STAFF REPORT
COMMUNITY DEVELOPMENT DEPARTMENT

HEARING DATE: 10/13/2020
 TO: Mayor & City Council
 FROM: Joe Dodson, Associate Planner
 208-884-5533
 SUBJECT: H-2020-0022
 Modern Craftsman at Black Cat

PLAT SHOWING
MODERN CRAFTSMAN AT BLACK CAT
BEING LOTS 1 & 2, BLOCK 1 OF PUMA SUBDIVISION
LOCATED IN THE SW 1/4 OF THE SW 1/4 OF SECTION 22
TOWNSHIP 4 NORTH, RANGE 1 WEST, BOISE MERIDIAN
MERIDIAN, ADA COUNTY, IDAHO
2020

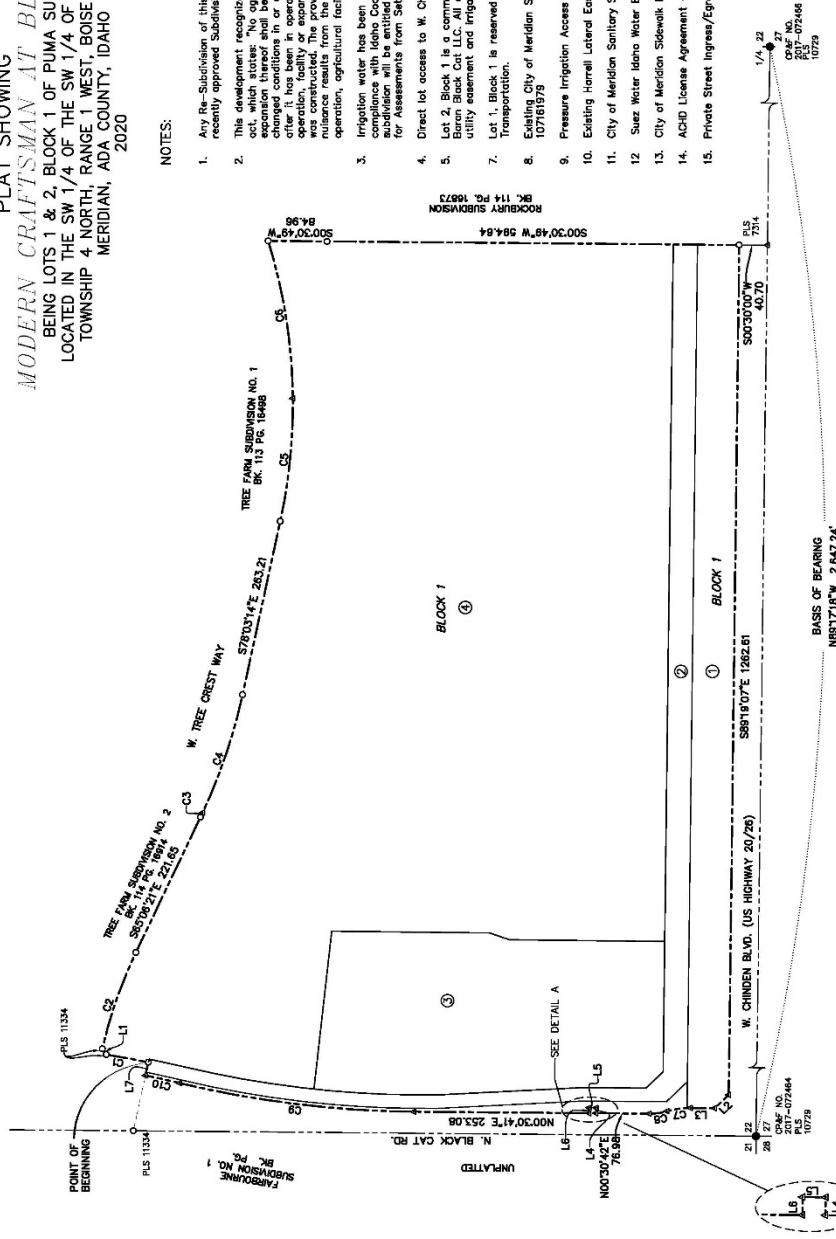
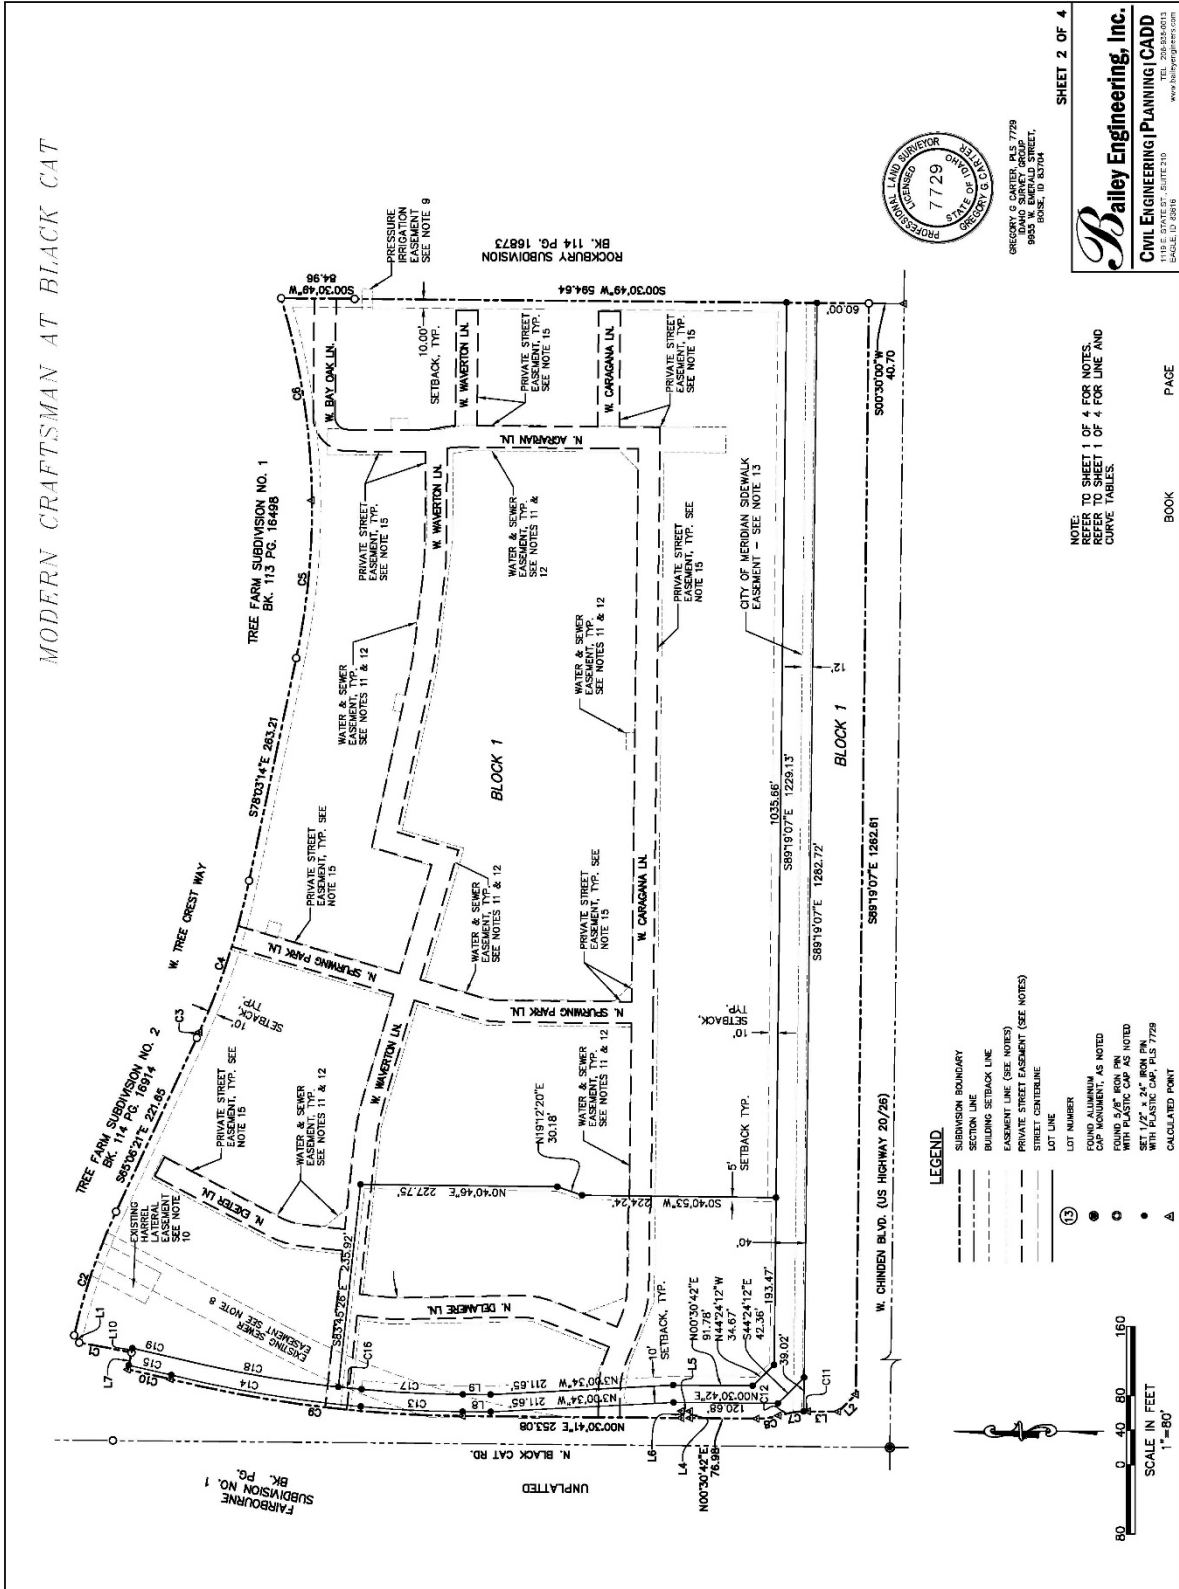
standards in 11-3B-7C.2; Staff is recommending a condition of approval to amend the plat to show the entire buffer along N. Black Cat within a common lot. Per UDC 11-3H-4D, and within the required buffer along SH 20/26, the Applicant is also required to build a noise attenuation wall or wall and berm combination at least 10-feet in height, measured from the height of the centerline of the highway. The Applicant is proposing a wall/berm combination that appears to meet the height requirement. Staff notes that this wall is also required to modulate over the course of its length. The submitted landscape plans do not appear to show this modulation so the Applicant will be required to correct the plans prior to final plat submittal.

2. The short plat included in Section VII.B, dated June 2020, shall be revised as follows prior to the City Council hearing:
 - a. ~~Revise the plat to include the entire required landscape buffer along N. Black Cat Road in a common lot(s) per UDC 11-3B-7C.2.~~

- ~~b. Add common lot or perpetual ingress/egress easement for the private streets in accord with UDC 11-3F-3B.3.~~
 - c. Stamped and signed by the licensed land surveyor.

D. Revised Landscape Plans (date: 6/18/2020 8/7/2020)

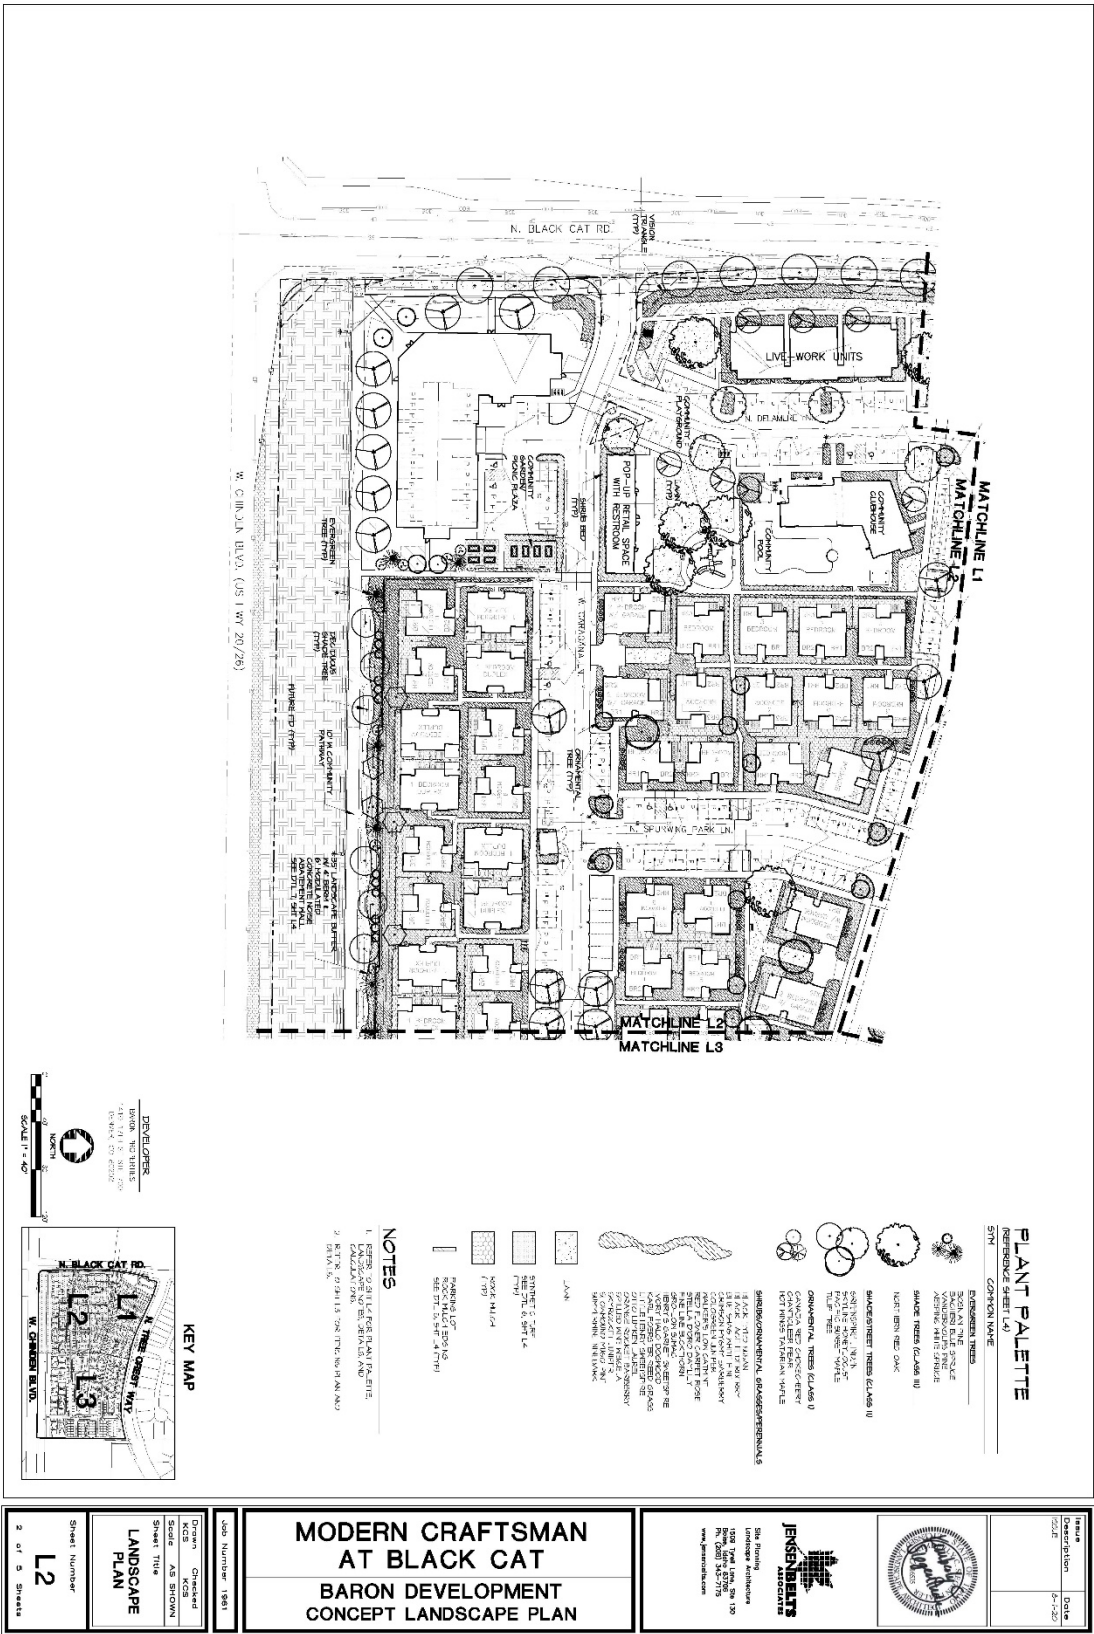
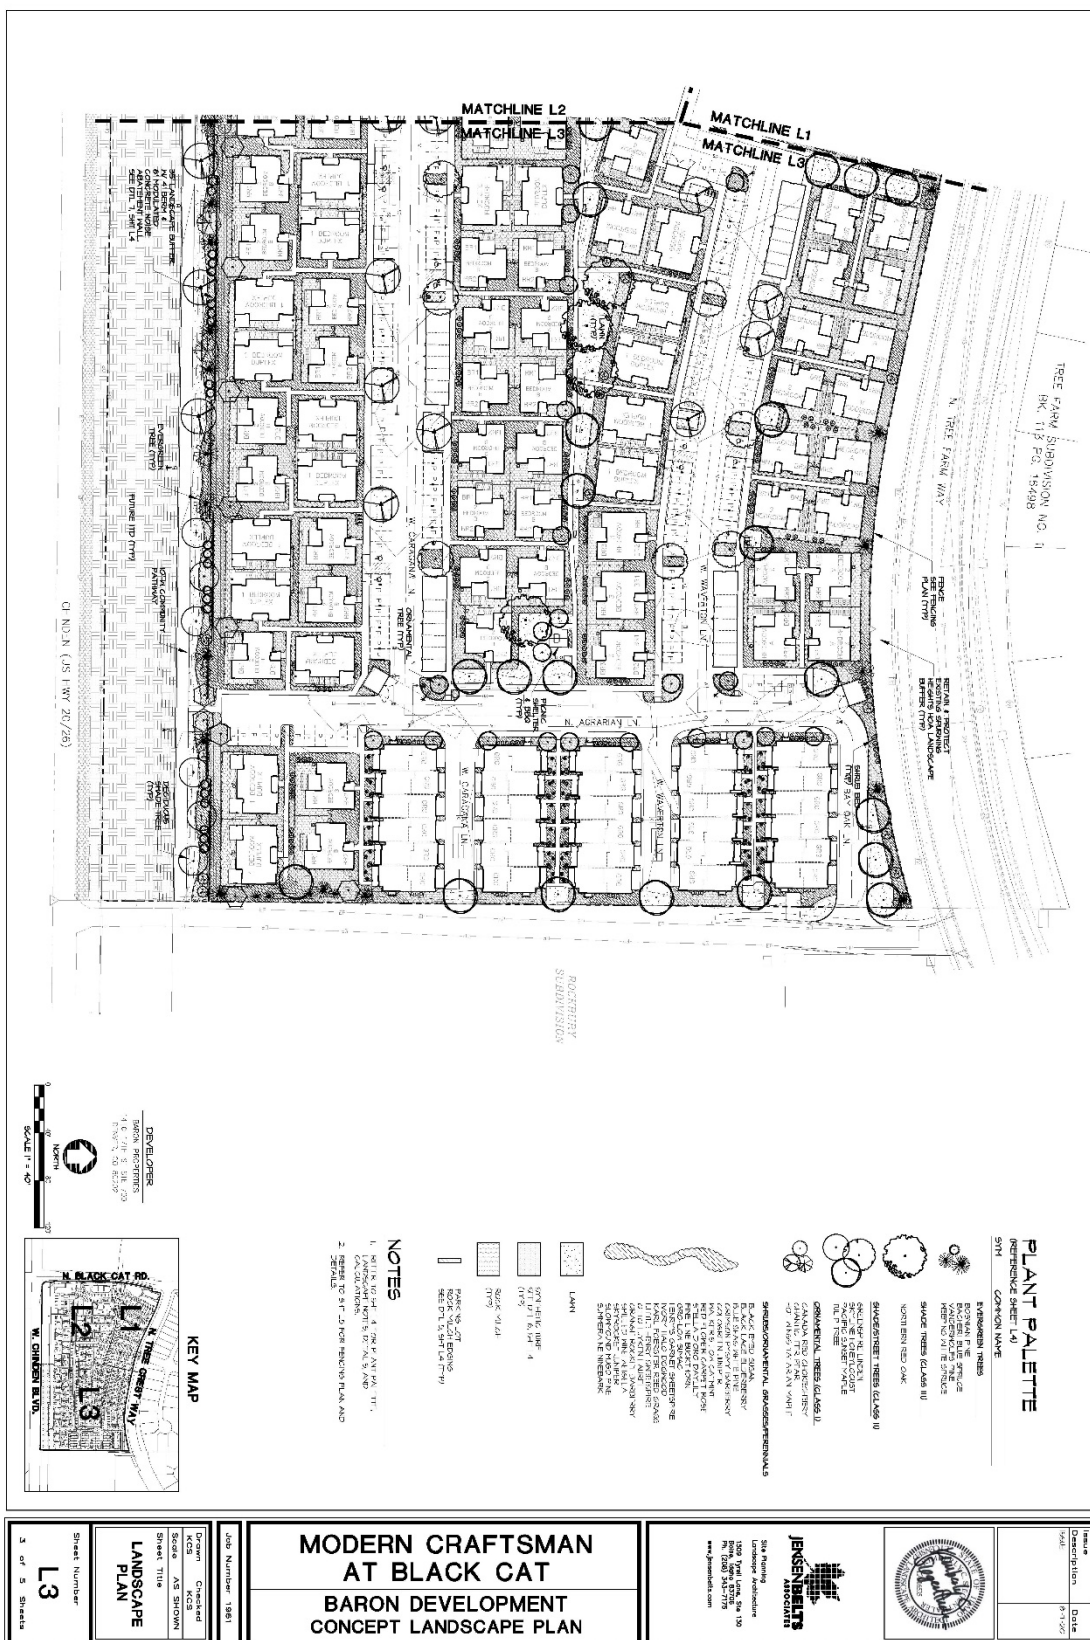
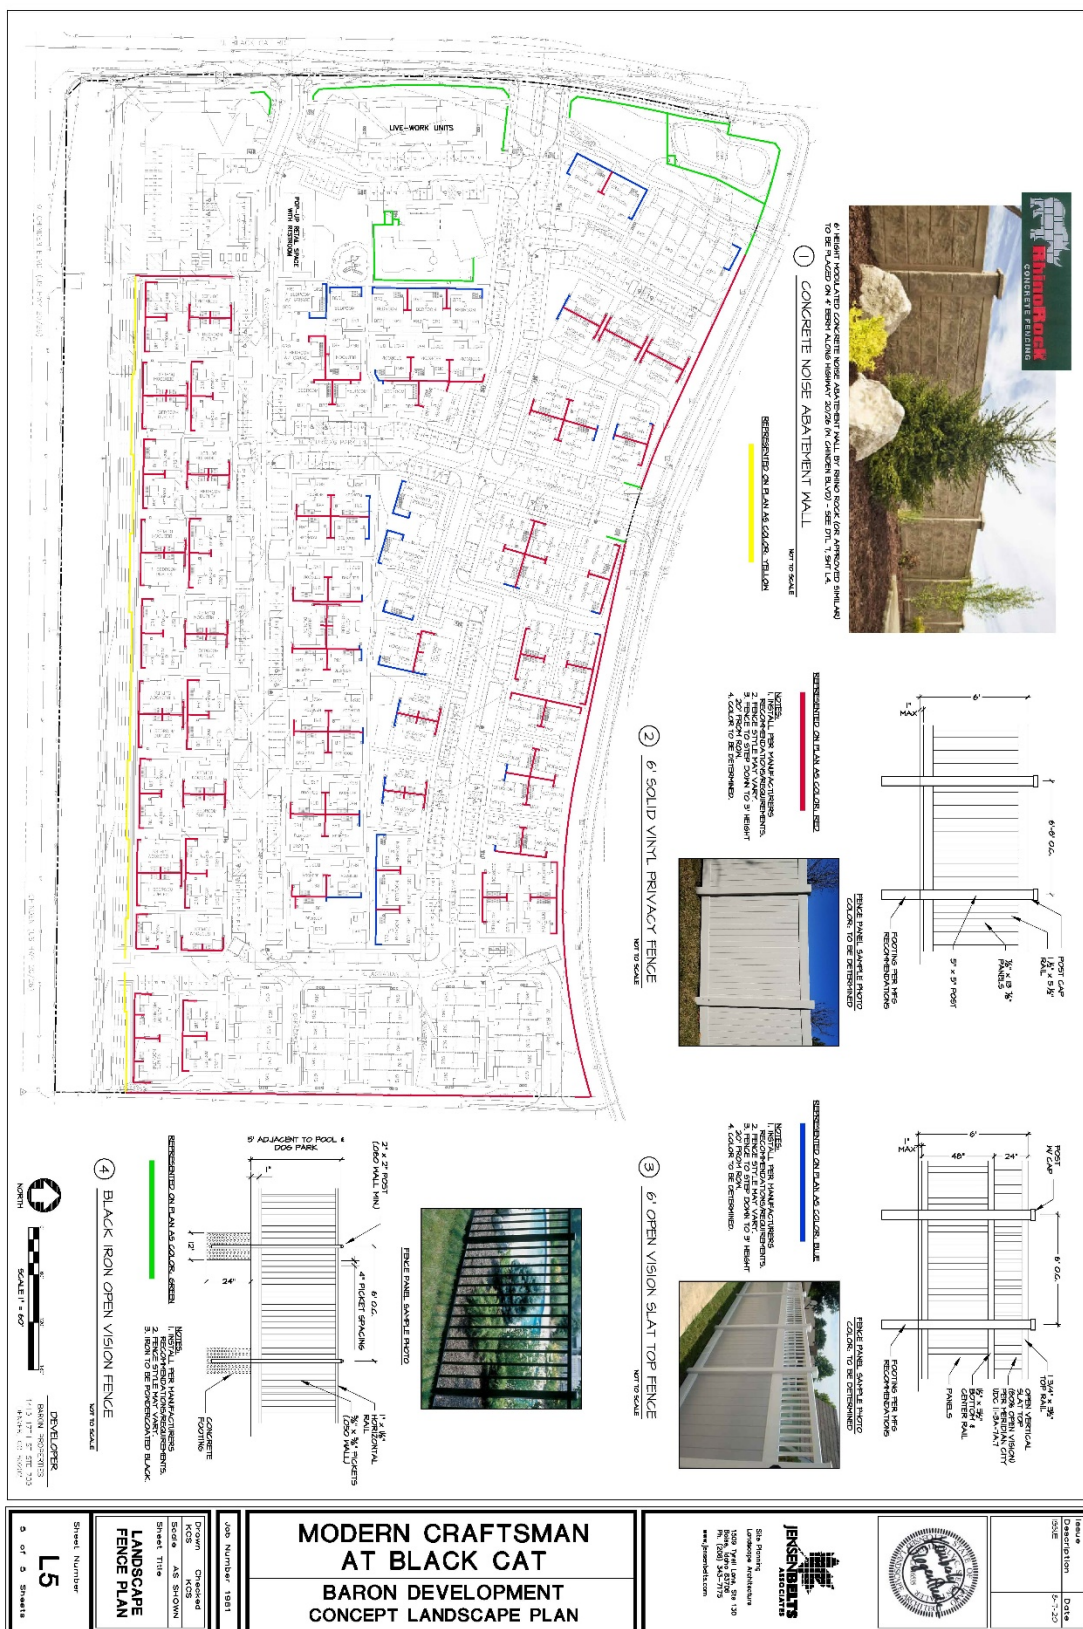
On the submitted landscape plans, there are no proposed trees or shrubs shown within the required landscape buffer between the commercial lot and SH 20/26. This area of the landscape buffer is also required to be landscaped and Staff is recommending a condition of approval to include landscaping in this area beyond grasses. See Section VII.D for the submitted landscape plans.

Landscaping is required along all pathways (including micro-pathways) in accord with the standards listed in *UDC 11-3B-12C*. The total lineal feet of pathways with the required and proposed number of trees are NOT included in the Landscape Calculations table on the submitted landscape plans, sheet L.4. **The addition of this data in the calculations table will be required as a condition of approval.**

The City Arborist has also made comments on the subject application regarding its landscaping, specifically on the type of tree species proposed. Fraxinus “Ash” tree species attract a specific and invasive pest and it is the request of the City Arborist that projects start trying to replace these types of trees with other tree species. Therefore, Staff is recommending a condition of approval that the Applicant work with the City Arborist on an appropriate alternative to their proposed “Ash” tree selection.

- b. ~~Revise the landscape plans to show the required modulation in the required noise attenuation wall along W. Chinden Blvd. in accord with UDC 11-3H-4D.~~

- c. ~~Revise the landscape plans and add trees, shrubs, and other vegetative ground cover to the areas of the landscape buffers between the future commercial buildings and Chinden Blvd. and Black Cat Road in accord with UDC 11-3B-7C~~

- d. ~~Revise the landscape plans to add a 5-foot wide landscape buffer along the northern boundary of the commercial parking area to eliminate conflict of cars backing out into the path of traffic on the private street. The buffer shall be landscaped in accord with UDC 11-3B-8C.~~

- e. Revise the landscape plans to show trash receptacles and bags for waste disposal throughout the proposed dog park area.
 - f. Revise the landscape plans to mirror any changes made to the site plan and plat.

- g. Show the common lot dedicated for future ITD right-of-way (Lot 1, Block 1) to be landscaped with grass and not gravel.
- 4. The residential elevations included in Section VII.G, dated February 2020, shall be revised as follows at least 10 days prior to the City Council hearing; are approved as submitted.

TOWNHOUSES - 6 PLEX

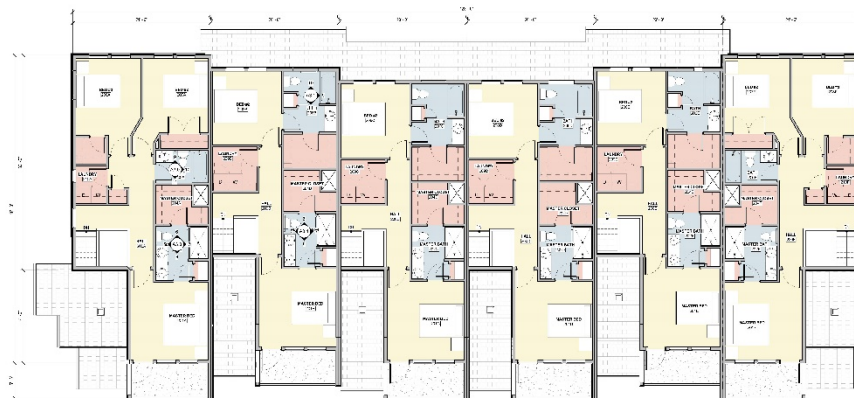
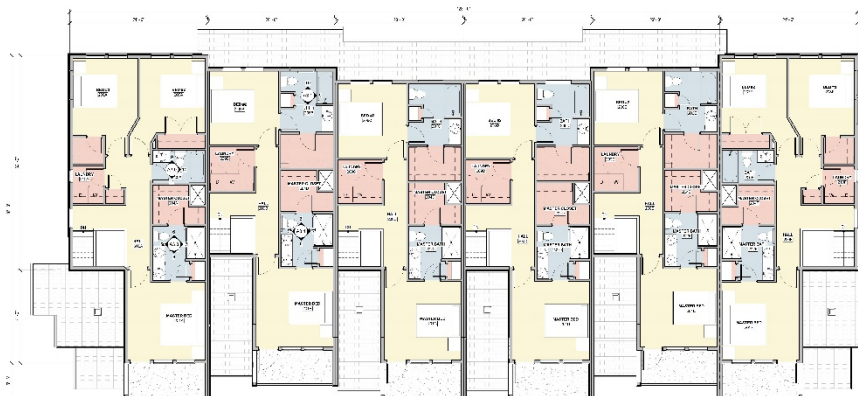
The submitted elevations for the proposed townhome home units show only one field material, stucco. The ASM requires at least two field materials for multi-family development for facades as long as those shown. Staff recommends the Applicant include more of the proposed lap siding along both the front and rear facades to meet the intent of the ASM goals. In addition, the ASM notes that no two multi-family buildings should look the same. To ensure compliance with at least the intent of this requirement, the Applicant should create differentiation between some of the 6-plex, townhome buildings through differing architectural designs and color palettes. Staff is recommending conditions of approval to correct this.

- a. ~~Add additional area of a secondary field material for the proposed townhome units to help break up the large amount of stucco as a field material.~~
